ADDENDUM NO. 2

- A. Date: 19 March 2013
- B. From: Bahr Vermeer and Haecker Architects, Ltd.
- C. To: Prospective Bidders.
- D. Project: Lexington Public Schools Lexington Middle School and Community Recreation Facility Addition 100% Contract Documents
- E. This addendum is issued by the Architect to all bidders of record prior to receipt of proposals. Bidders shall acknowledge receipt of this addendum by so indicating on the Bid Form. Failure to do so may subject Bidder to disqualification.
- F. All information and instructions given herein shall become a part of the Contract Documents.

ADDENDUM # 2

PROJECT Lexington Middle School & CRF Addition

E3.1C

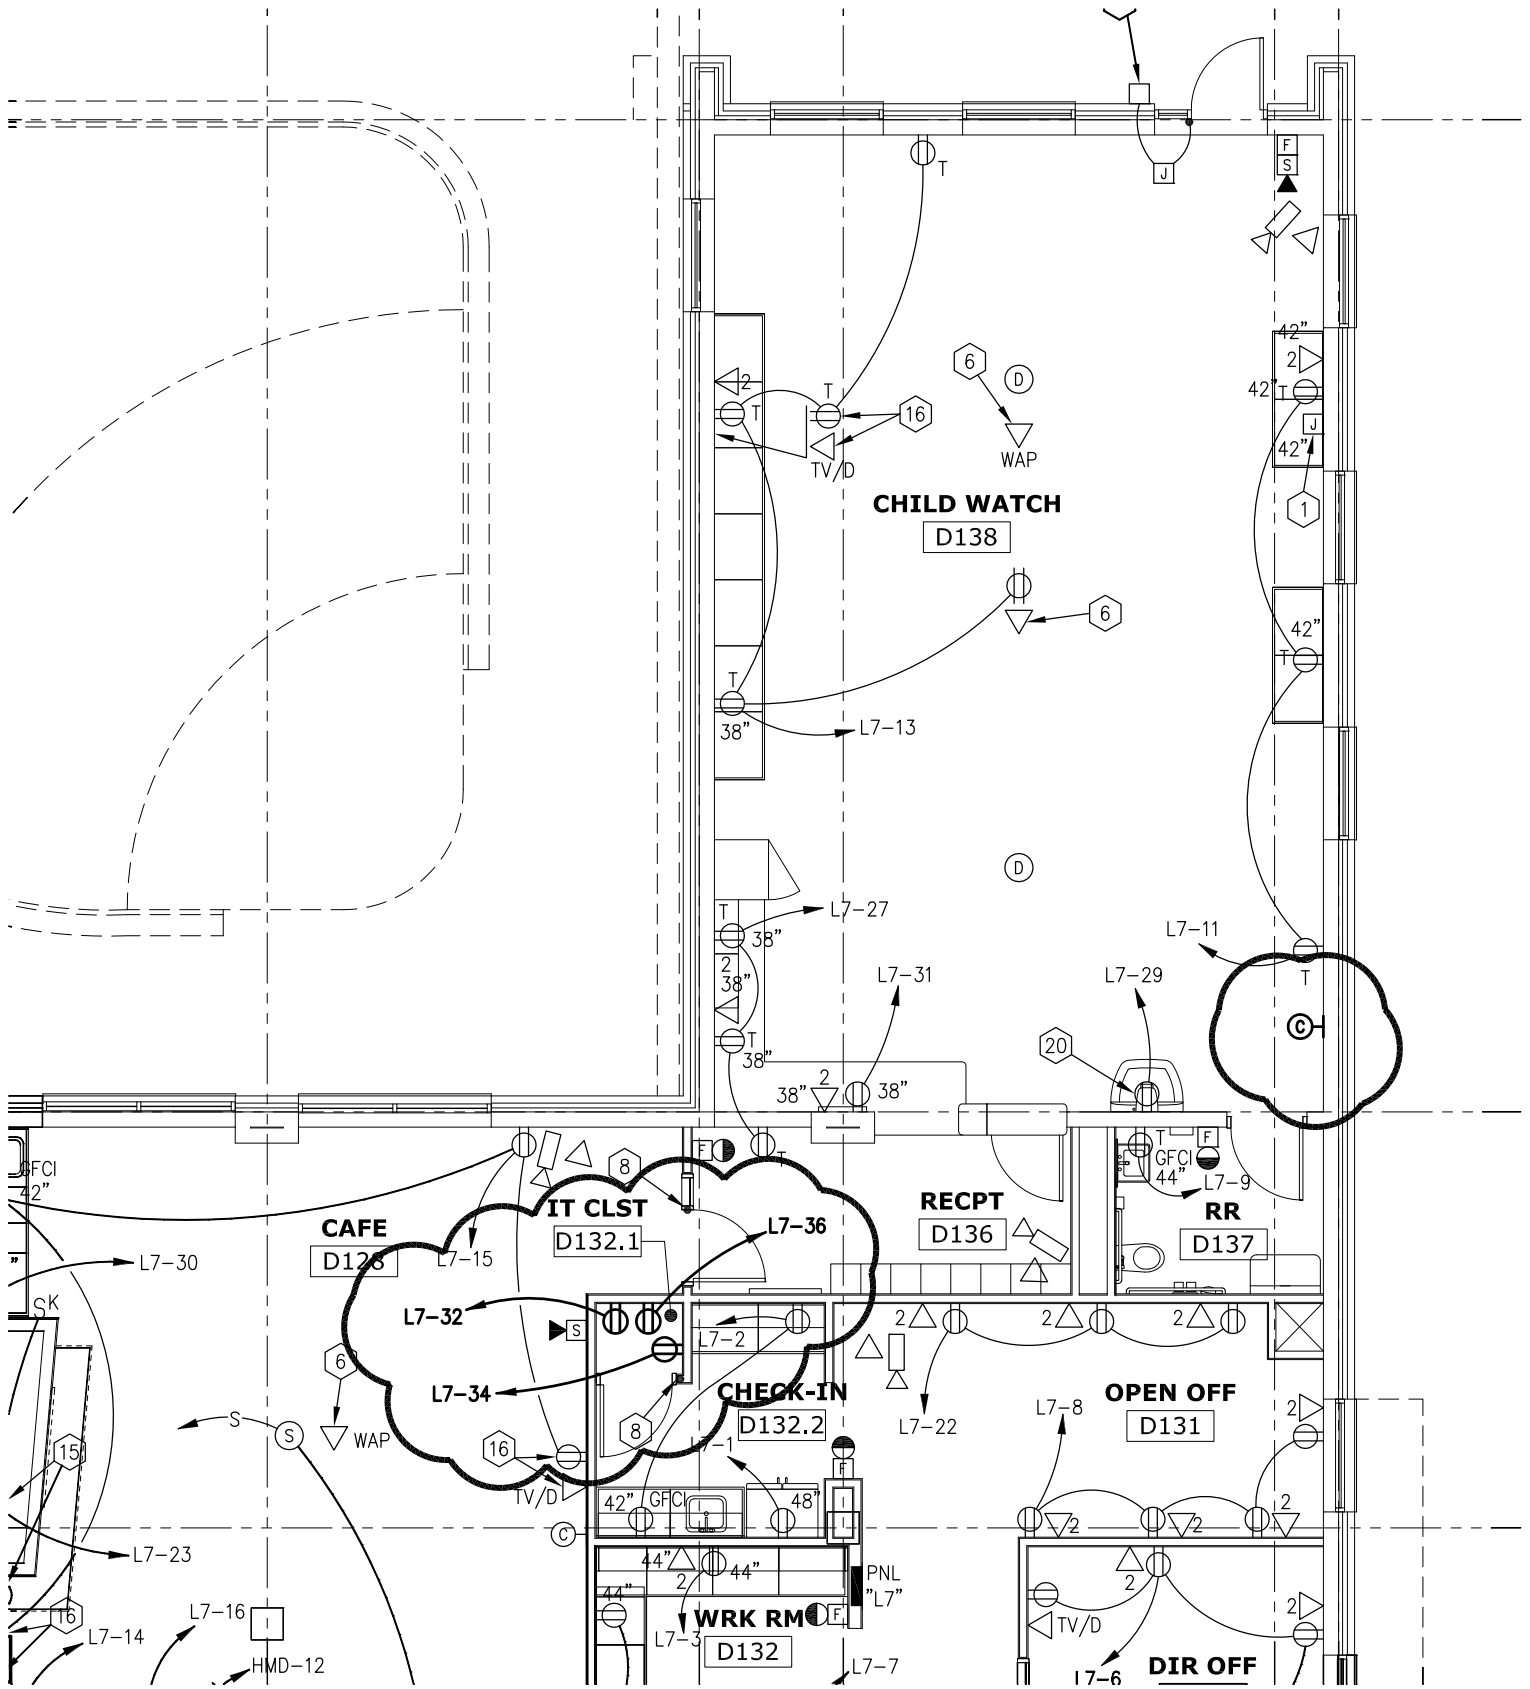
3. Sheet E3.1B
 - A. See attached drawing E3.1B #1 for speakers in kitchen area.
4. Sheet E3.1C
 - A. See attached drawing E3.1C #1 for additional clocks.

SHEET
E3.1D

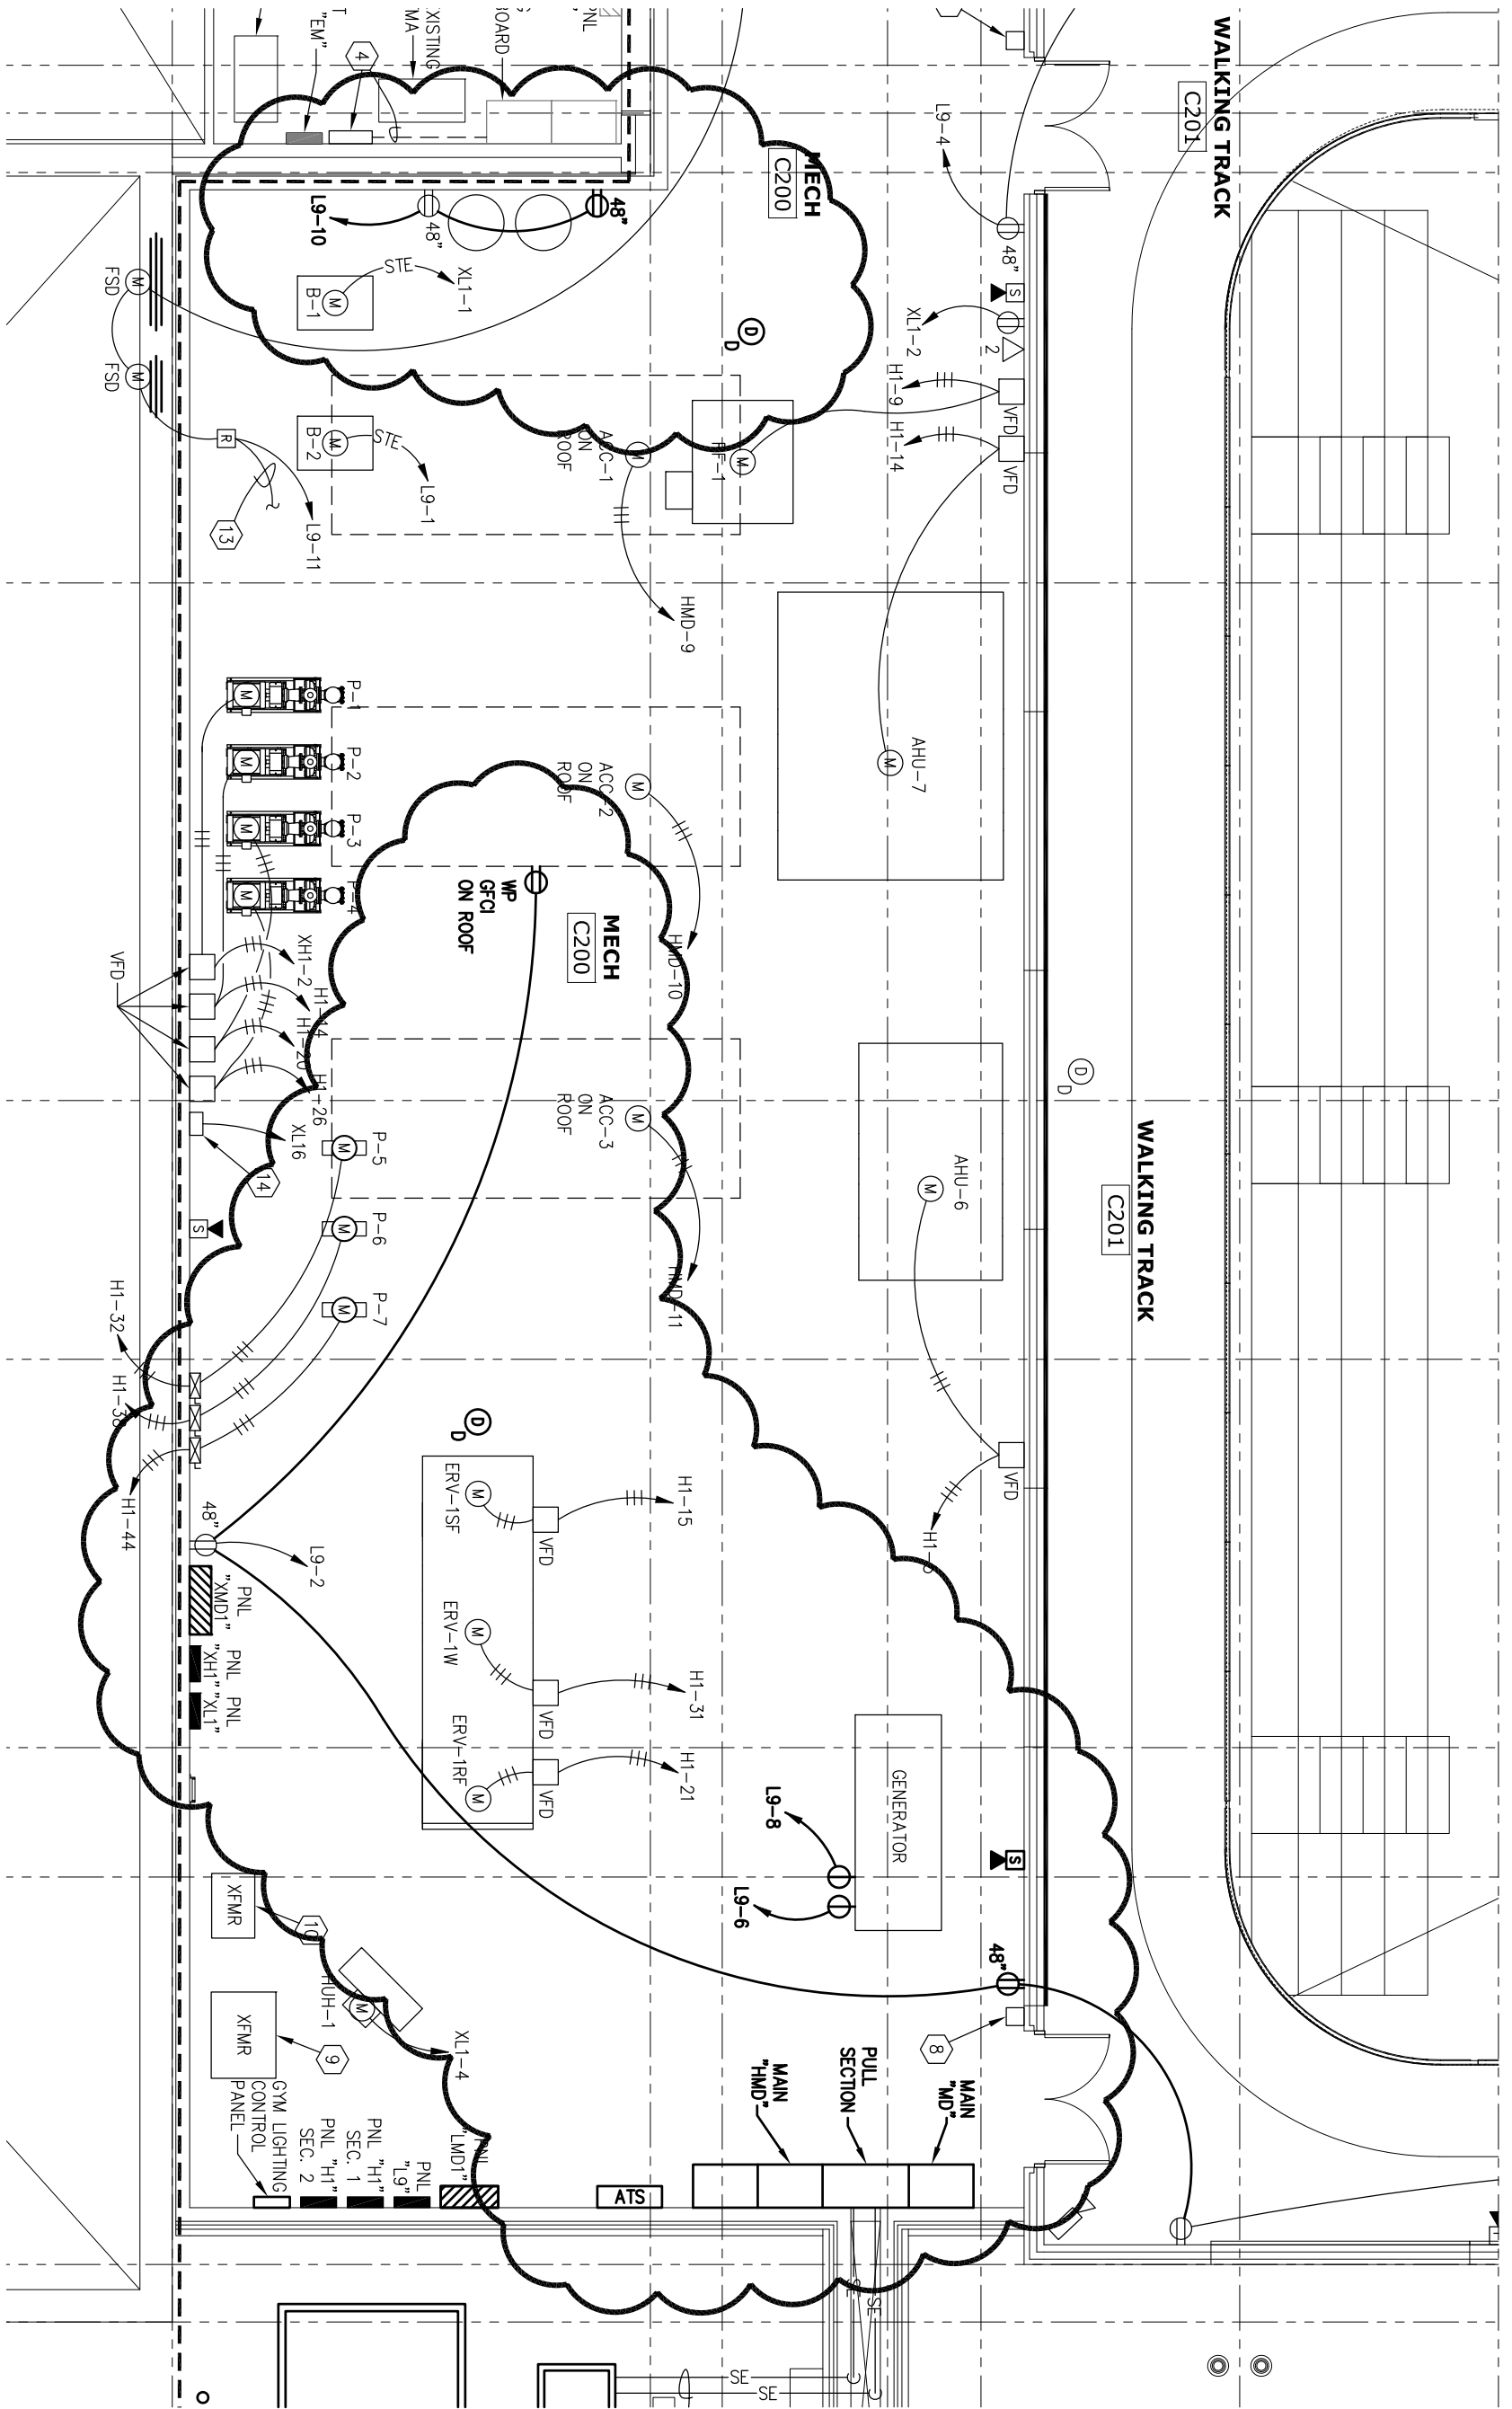
5. Sheet E3.1D
 - A. In W. LCKR D123 one of the circuits, L8-24, connected to a hand dryer shall be changed to L8-26.
 - B. Add clock in Child Watch D138. See attached drawing E3.1D #1.

- C. Add receptacles to IT CLST D132.1. See attached drawing E3.1D #1.
 - D. In Conference D134, provide 2 data cables and jacks in floor box. Provide mounting brackets for jacks.

03/19/13
SHEET
E3.2C
ATTACHMENT NO.
1
BJF

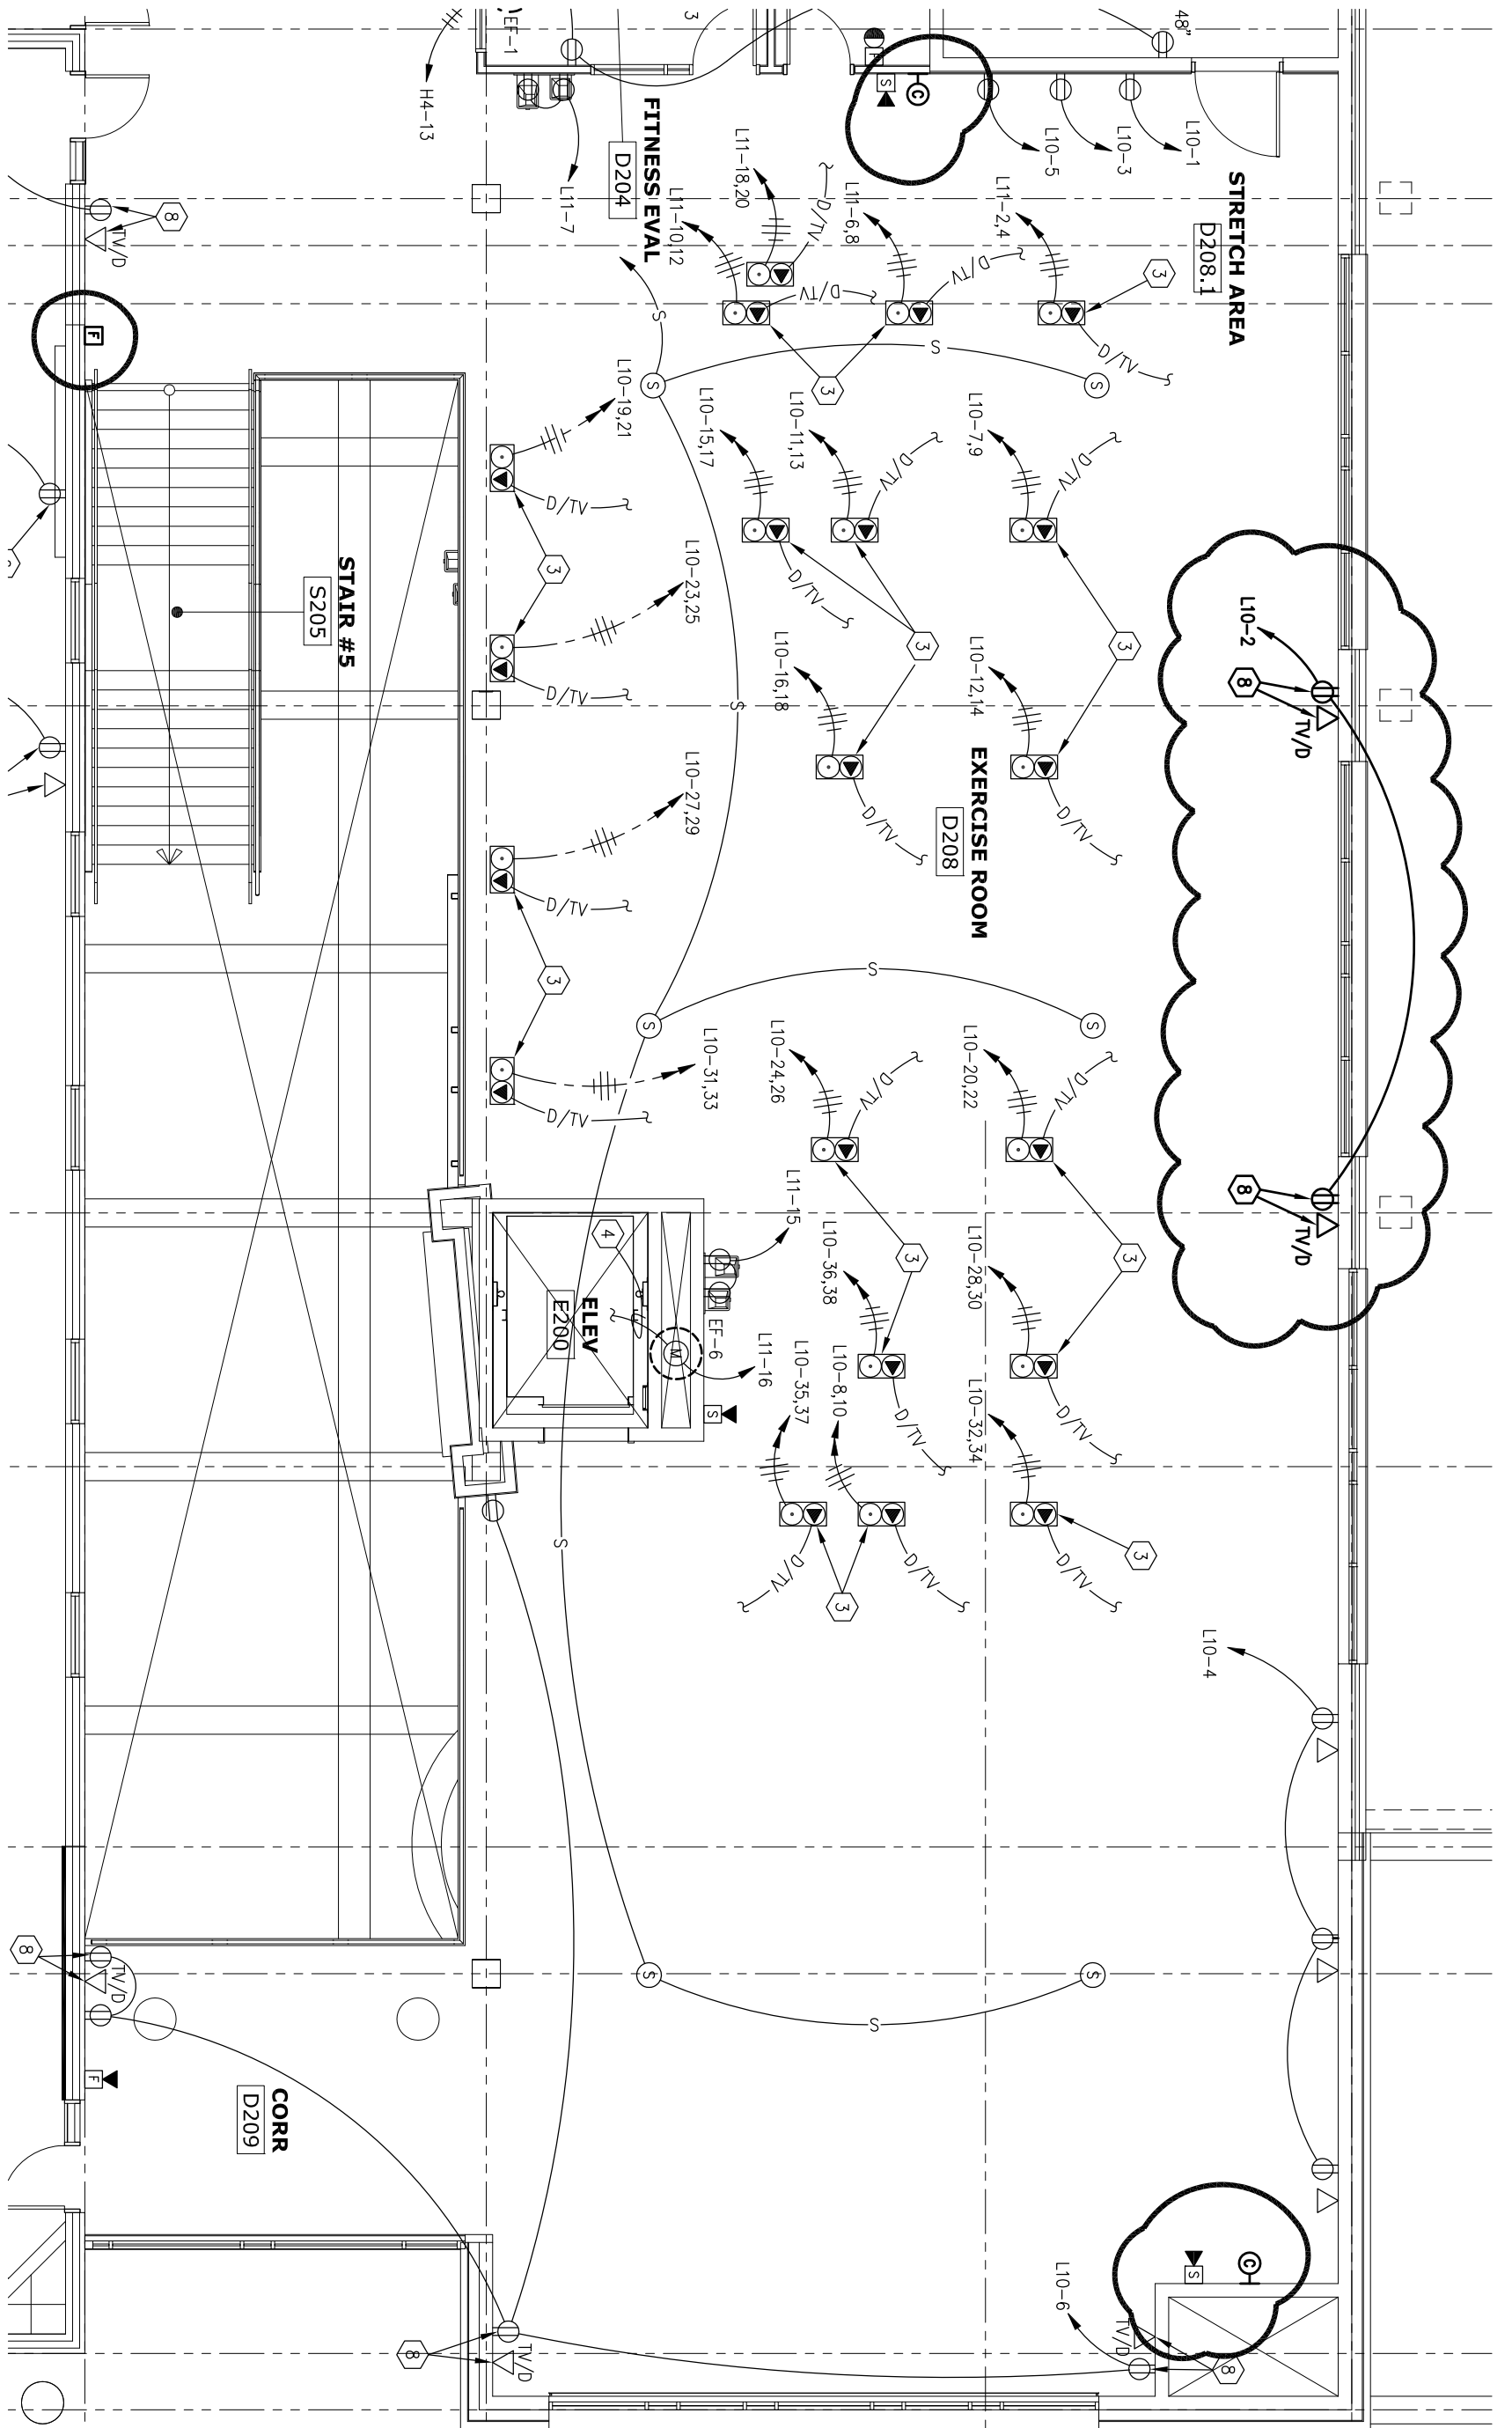
6. Sheet E3.2C
 - A. Provide circuit to generator engine heater and one circuit to generator battery charger. See attached drawing E3.2C #1.
 - B. Provide receptacle on west wall for fill tanks. See attached drawing E3.2C #1.

- C. Provide receptacle on roof for roof service of equipment. Do not mount on access panel of equipment. See attached drawing E3.2C #1.
 - D. Relocate the ATS to east wall. See attached drawing E3.2C #1.

- E. Added a duct smoke detector in the return duct of RF-1. See attached drawing E3.2C #1.
 - F. Added a duct smoke detector in the supply of ERV-1. See attached drawing E3.2C #1.

- G. Re-arranged the switchboard layout. See attached drawing E3.2C #1.
 - H. When the existing generator is removed, the exhaust shall be removed and the roof penetration patched.

03/19/13
SHEET E3.2D
ATTACHMENT NO. 1
BJF

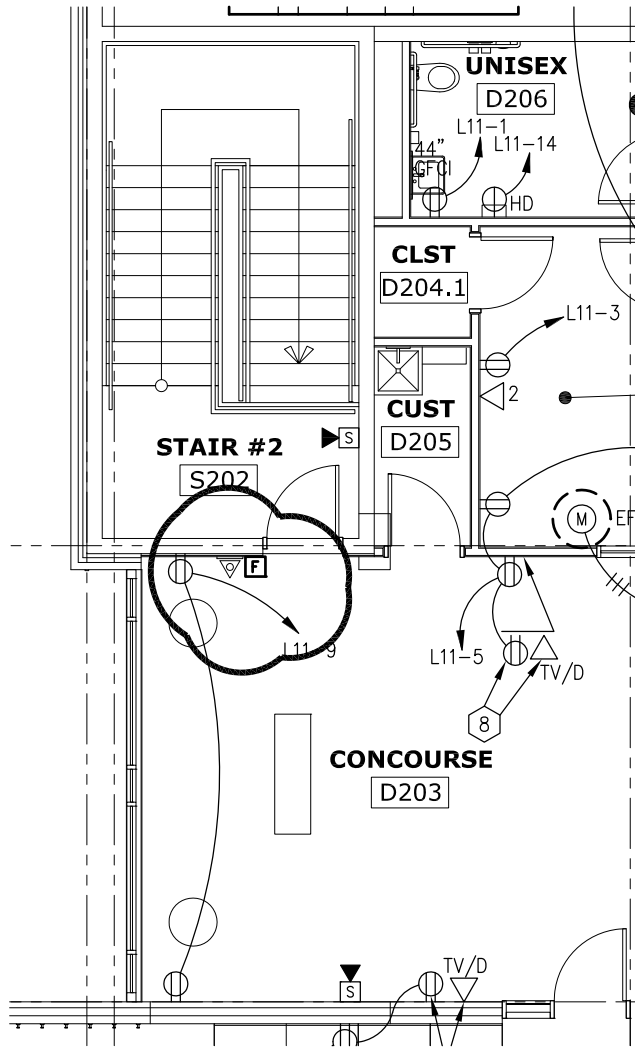
- B. Deleted 3 duplex power outlets and 2 data outlets along north wall in Exercise Room D208. See attached drawing E3.2D #1.
 - C. Delete Note 11 in Exercise Room D208.

- D. Change Note 4 to read “Provide relay for connection by Controls Contractor.”
 - E. Added two clocks in Exercise Room D208. See attached drawing E3.2D #1.

- F. The speaker cable in the Rec Center shall be extended to IT CLST D132.1. See attached drawings E3.2D #1 & #2.
 - G. Add a fire alarm pull station by Stair #2 S202 and by Stair #5 S205.
